**7TH AVE TOWNHOMES  
BUILDING A**

<b>ISSUE</b>	<b>DATE</b>
BLDG PERMIT APPLICATION	03/06/2025
PERMIT COMMENTS	04/29/2025

**City of Puyallup**  
Development & Permitting Services  
**ISSUED PERMIT**

**City of Puyallup Building REVIEWED FOR COMPLIANCE**

SITE PLAN

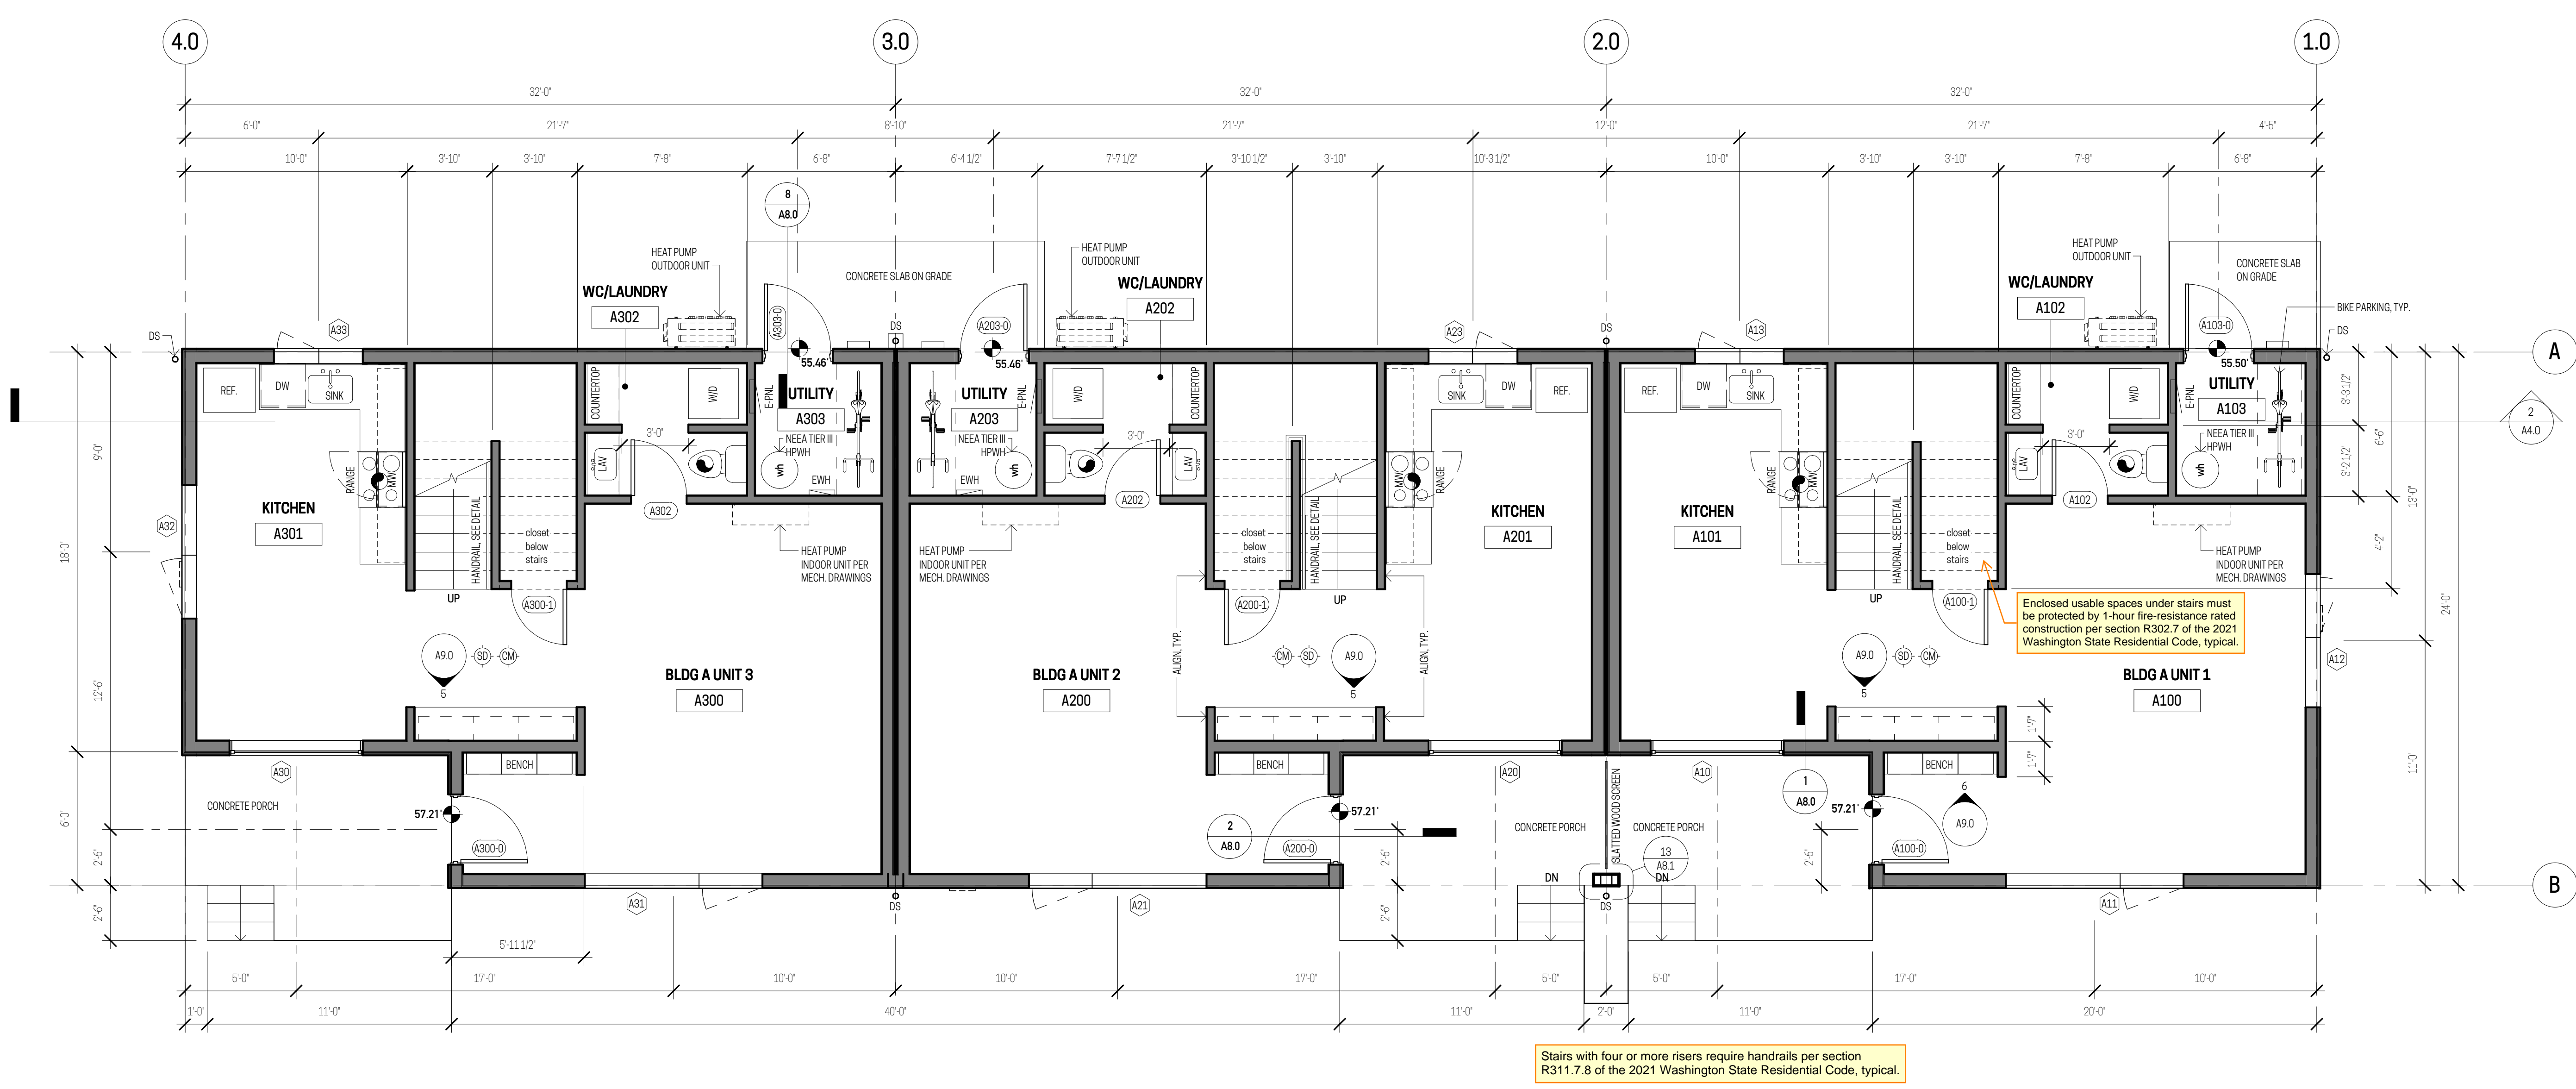
Multiple Site Plans were submitted. The Building inspector must be provided with the Site Plan that has the Planning Department's stamp during inspection.

### BUILDING A - MAIN LEVEL PLAN

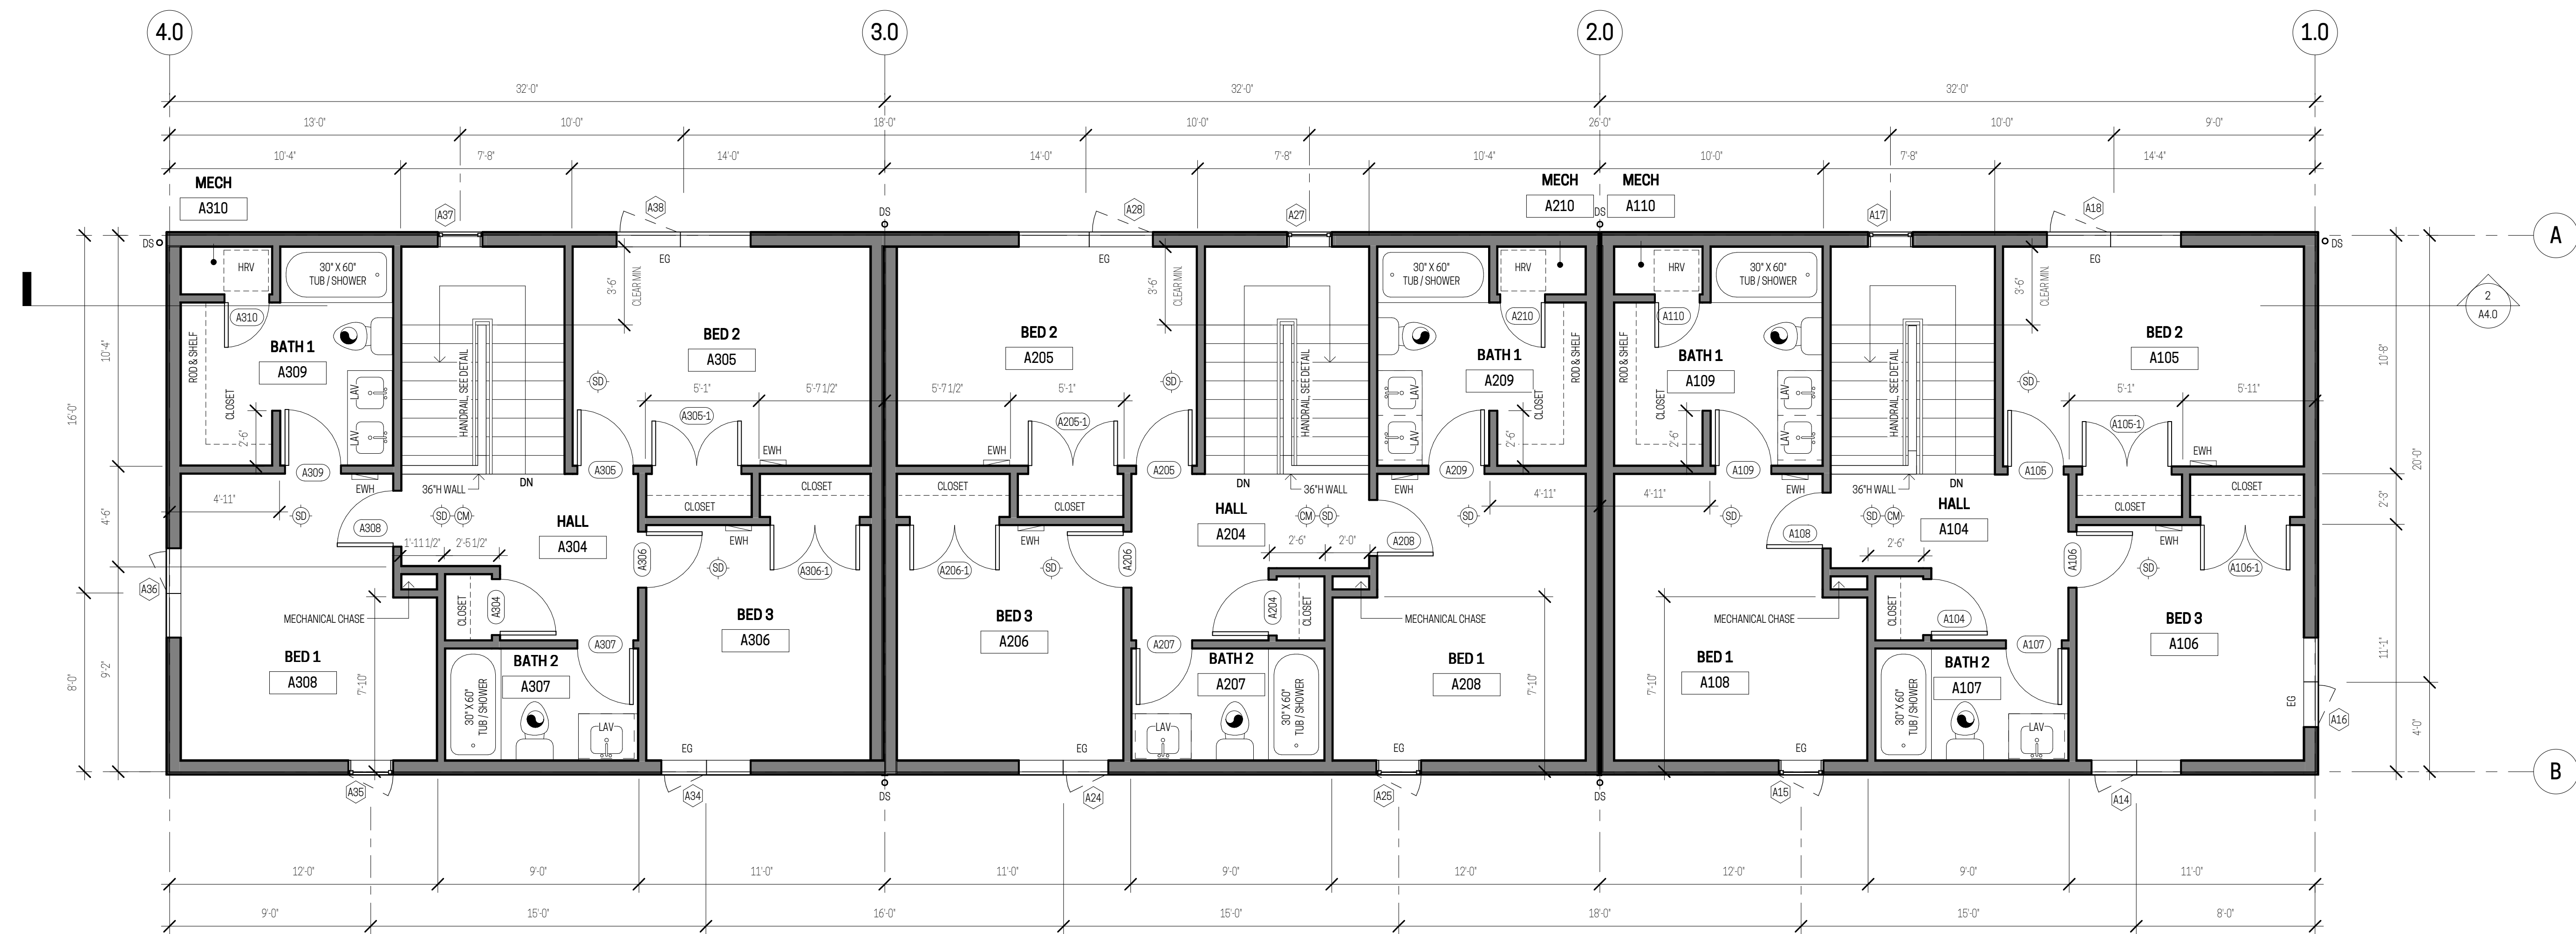
Fall protection will be required at the upper floor operable windows if the sill height is 24" or less above the finished floor, per section R312.2.1 of the 2021 Washington State Residential Code, typical at similar.

UPPER LEVEL PLUMBING PLAN SCALE: 1/4" = 1'-0"

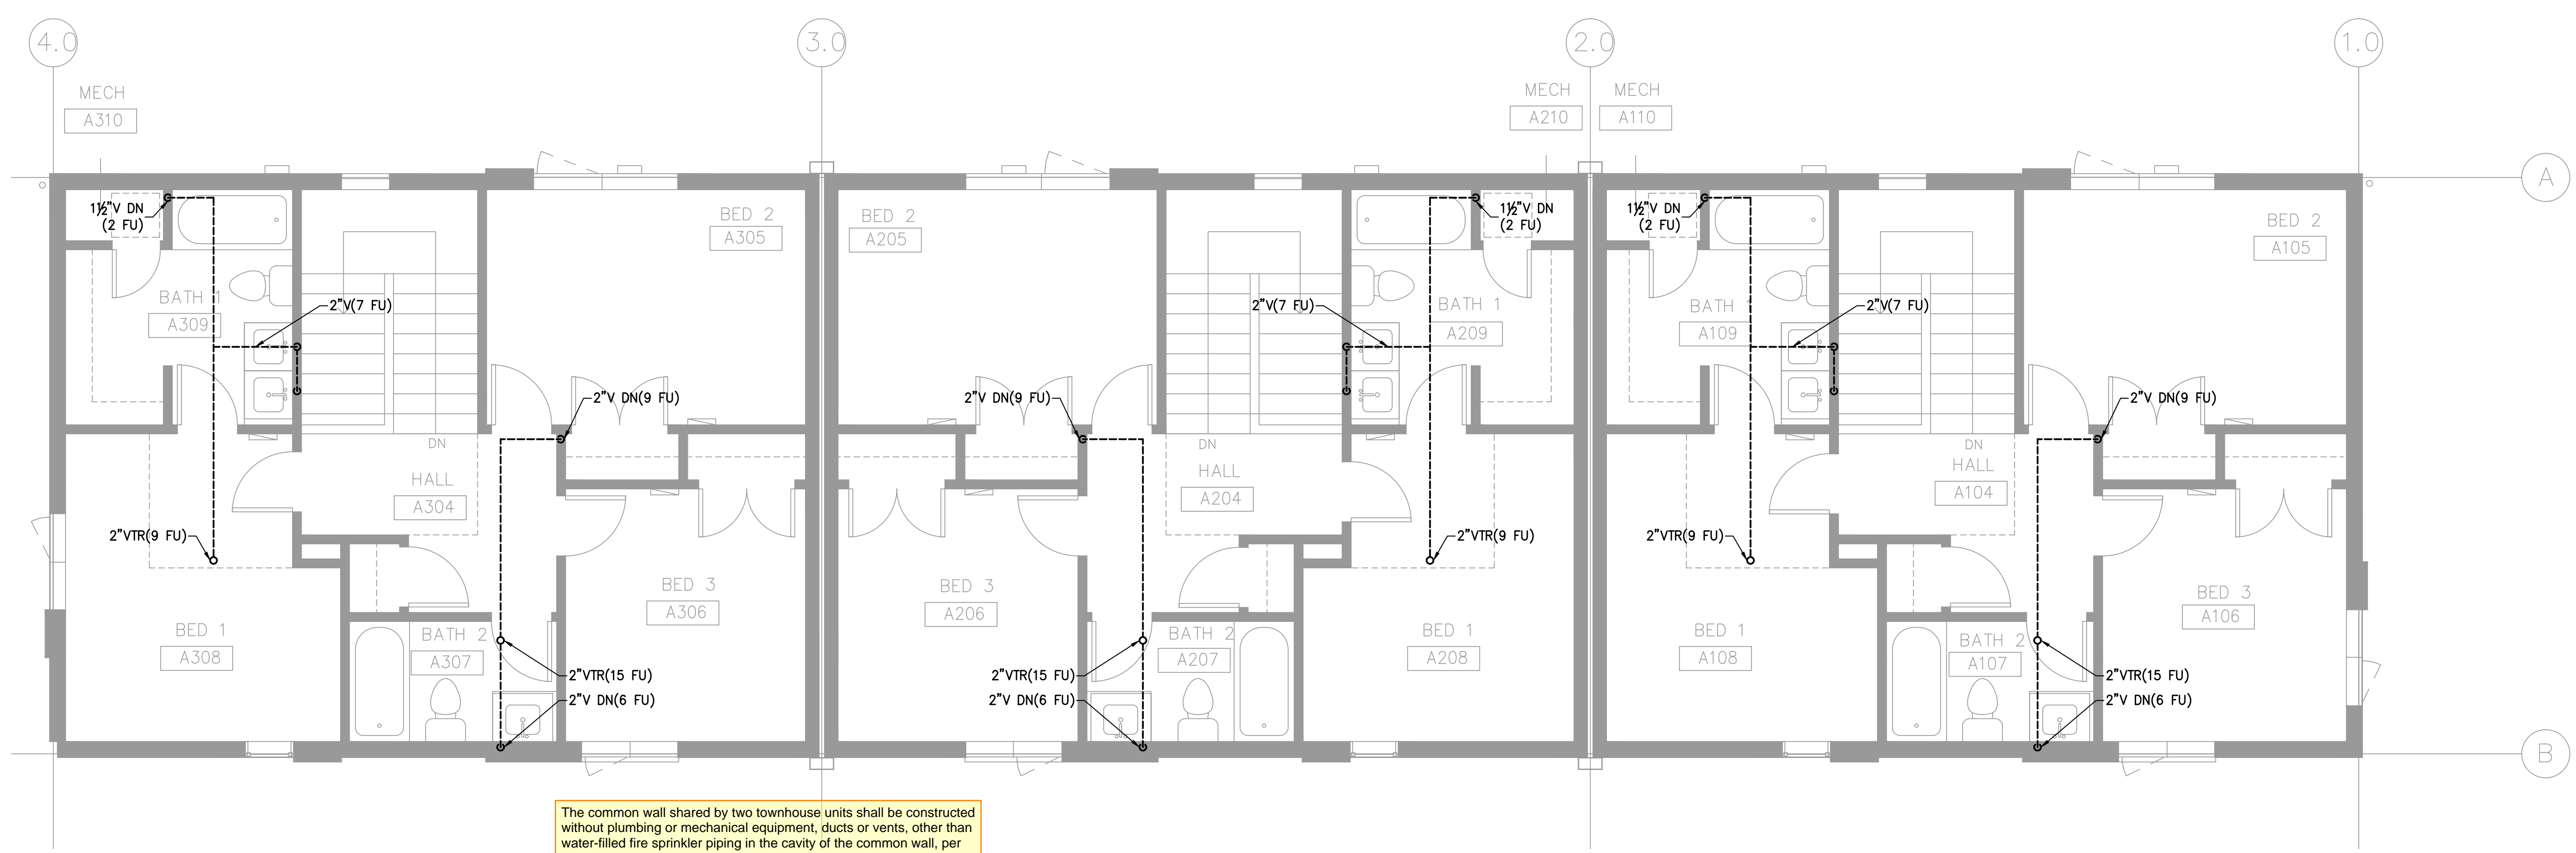
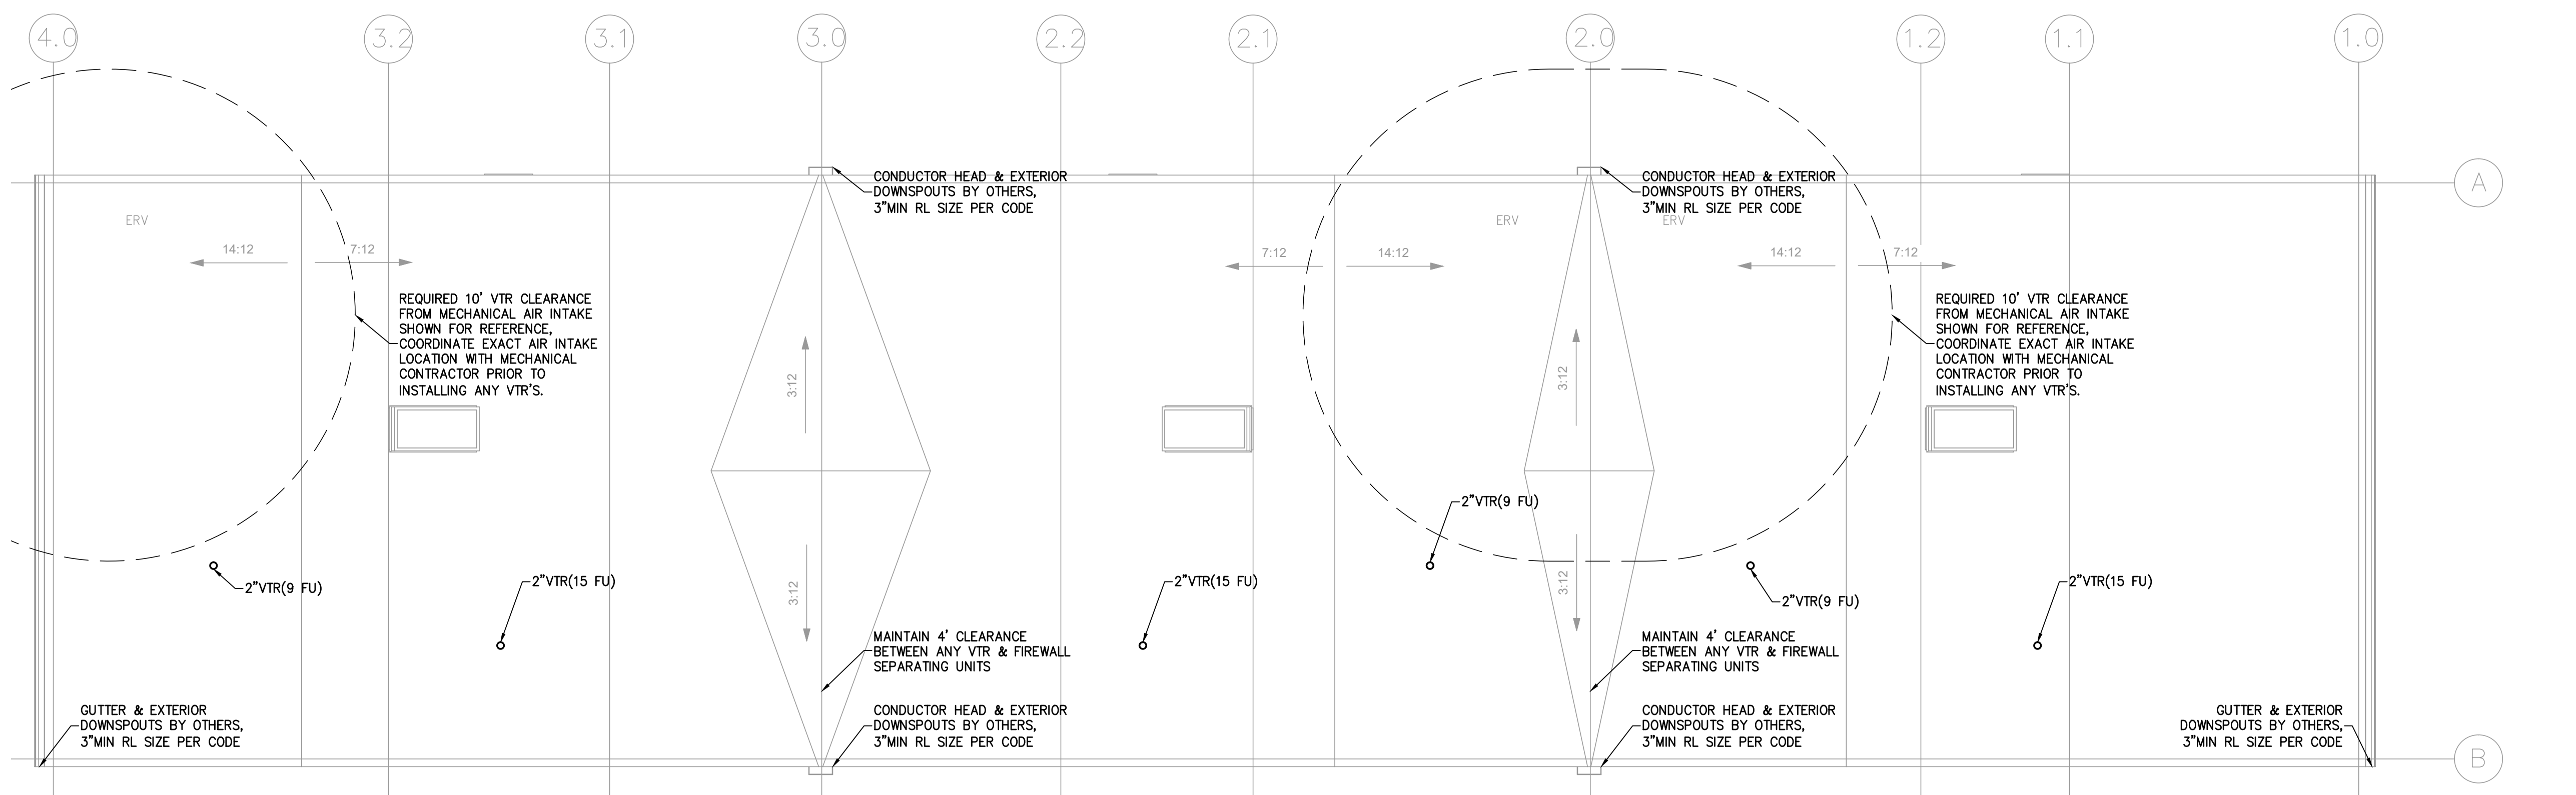
The common wall shared by two townhouse units shall be constructed without plumbing or mechanical equipment, ducts or vents, other than water-filled fire sprinkler piping in the cavity of the common wall, per section R302.2.2 of the 2021 Washington State Residential Code.
